# UNITED STATES PATENT AND TRADEMARK OFFICE

APPLICATION NO.	FILING DATE	FIRST NAMED INVENTOR	ATTORNEY DOCKET NO.	CONFIRMATION NO.
10/715,747	11/18/2003	Kenneth J. Kirchhoff	59137US002	5513
32692	7590	01/05/2006	EXAMINER	
3M INNOVATIVE PROPERTIES COMPANY PO BOX 33427 ST. PAUL, MN 55133-3427			CHANG, YEAN HSI	
			ART UNIT	PAPER NUMBER
			2835

<b>Office Action Summary</b>	<b>Application No.</b> 10/715,747	<b>Applicant(s)</b> KIRCHHOFF, KENNETH J.	
	<b>Examiner</b> Yean-Hsi Chang	<b>Art Unit</b> 2835

## **DETAILED ACTION**

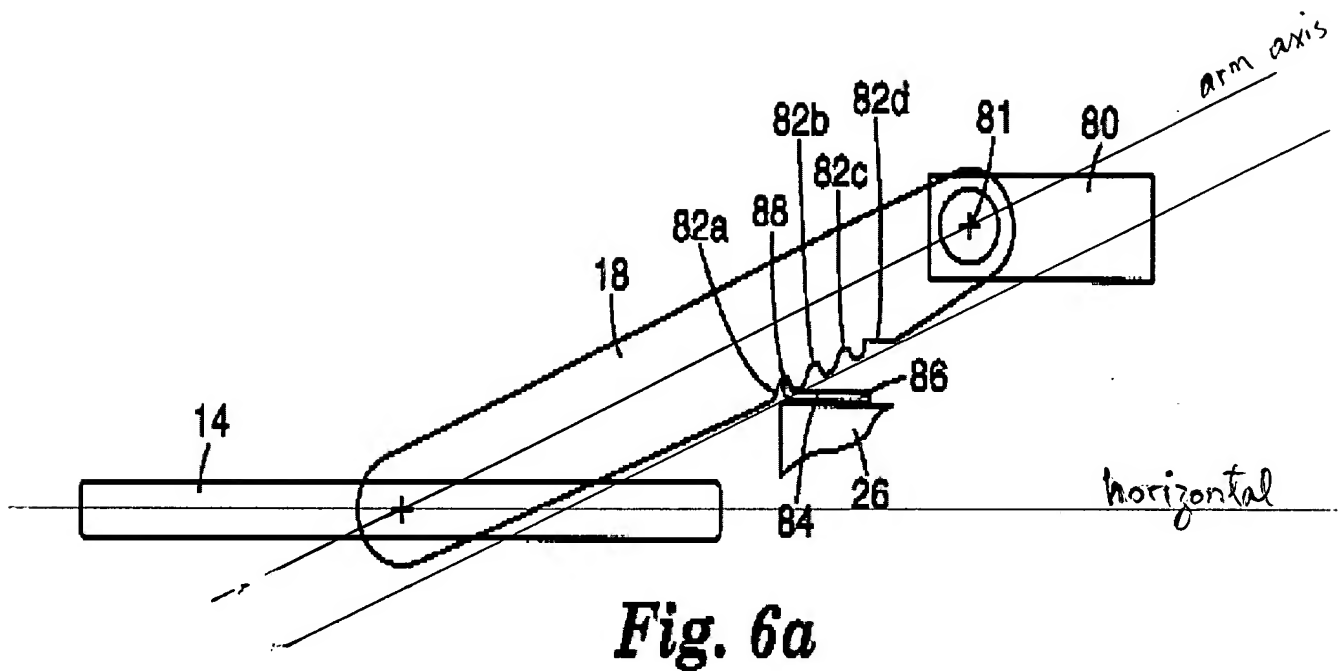
Regarding claims 1 and 18, Applicant argues, "Looking specifically at Figure 6a, if one were to draw an imaginary arm axis from the pivot point 8(1) to the point where arm 18 connects with keyboard tray 14, that imaginary line would be an arm axis. If one were to measure the vertical distance between notches 82a, 82b, 82c, and 82d and the imaginary arm axis, it would be all of the same height.", "the arm design of the '728 patent does not use a non-uniform arm, as Applicant has used in the instant application.", and "Furthermore, the '728 patent does not suggest the use of an arm design where the vertical distance between the notch and the imaginary arm axis increases."

As instructed by the Applicant, an imaginary arm axis is drawn in red in Fig. 6a of Hagglund as attached below, and a line parallel to the axis is also drawn in the Figure. It is clearly shown that the arm design of '728 patent does use a non-uniform arm (from 10.5 mm at the pivot point to 12.5 mm at the notches). The vertical distance between a notch and the imaginary arm axis varies as the arm rotates even though the distances between the notches and the imaginary arm axis are equal.
